Access Compliance Report Public Rights-of-Way (Curb Ramps)

Main Street: CRESTKNOLL_DR	Cross Street: FAIRLYNN_BLVD	Location:	SE
----------------------------	-----------------------------	-----------	----

ADA ID: RPAT210923094940	Ramp Type: Type 4 - Parallel	Initial Pass/Fail: Fail	Overall Compliance: No	Severity Score:	16
--------------------------	------------------------------	-------------------------	------------------------	-----------------	----

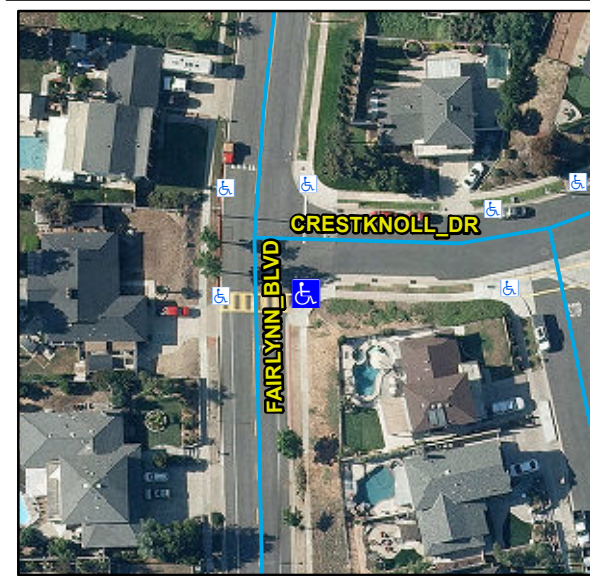
Compliance	Description	Data	Compliance	Description	Data
N/A	Ramp Length LT (in)	56	N/A	Ramp Length RT (in)	55
Yes	Ramp Width LT (in)	98	Yes	Ramp Width RT (in)	104
Yes	Ramp Run Slope LT (%)	8.1	No	Ramp Run Slope RT (%)	9.9
No	Ramp Cross Slope LT (%)	3.3	Yes	Ramp Cross Slope RT (%)	0.2
N/A	Landing Present	N/A	N/A	DWS Provided	N/A
N/A	Landing Length (in)	N/A	N/A	DWS Contrast	N/A
N/A	Landing Width (in)	N/A	N/A	DWS Length (in)	N/A
N/A	Landing Run Slope (%)	N/A	N/A	DWS Full Width	N/A
N/A	Landing Cross Slope (%)	N/A		DWS Offset Type	N/A
N/A	Landing Movement Obstructed?	N/A	N/A	DWS Offset Left (in)	N/A
	Landing Movement Type	N/A	N/A	DWS Offset Right (in)	N/A
N/A	Landing Shared	N/A			
N/A	Clear Space	Yes			
N/A	Clear Space To Crosswalk (in)	N/A			
N/A	Marked Crosswalk 1	No	N/A	Marked Crosswalk 2	Yes
	Crossing 1 Direction	N		Crossing 2 Direction	W
	Marked Crosswalk 1 Width (in)	N/A		Marked Crosswalk 2 Width (in)	120

Remove & Replace Curb Ramp With Two New Directional Ramps or Equivalent.

R304.5.3, R304.3.2, STD 1115
